Work Session of the Sandy Springs City Council was held on October 15, 2024 following PFA, Mayor Rusty Paul presiding.

- A. **2024-251** Presentation of the Concept Plan for the Peachtree Dunwoody Bike/Pedestrian Last Mile Connectivity Project (TS131)

### TS131 Peachtree Dunwoody Bike/Pedestrian Trail - LMC

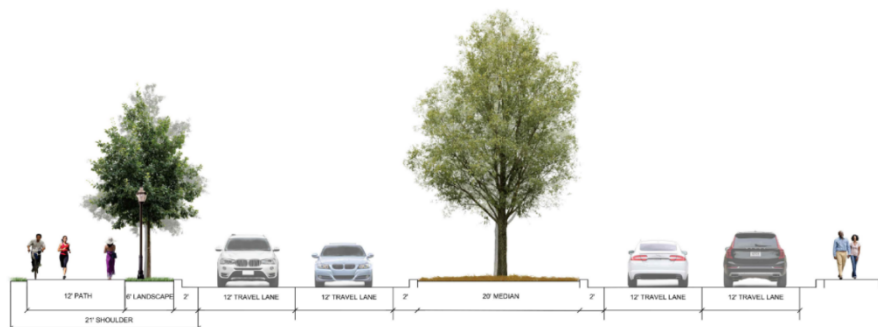
**Councilmember Melissa Mular** said this was mentioned as these paths have been developing. Due to concern with residents, will there be speed limits because of bikes, e-bikes, and pedestrians?

**Councilmember Mular** asked will there be a different signage warning for people on the trail for the entrances of Dunwoody Springs so they know traffic is coming out?

**Councilmember Jody Reichel** said there have been a lot of issues with trees and power lines with Georgia Power. Will the City work with Georgia Power?

**T-SPLOST Program Manager Johnson** said we need to look into this with the Transportation Unit.

**T-SPLOST Program Manager Johnson** said yes.

**T-SPLOST Program Manager Johnson** said we will. There is some utility cost associated with this because in some cases, sidewalks for example, you must pay for utility relocations, and if it is a widening you do not. We have utility budgeted for in case we have to do some relocations to avoid some of that, but generally those lines in this project are behind the multi-use path, and the trees will hopefully not conflict.
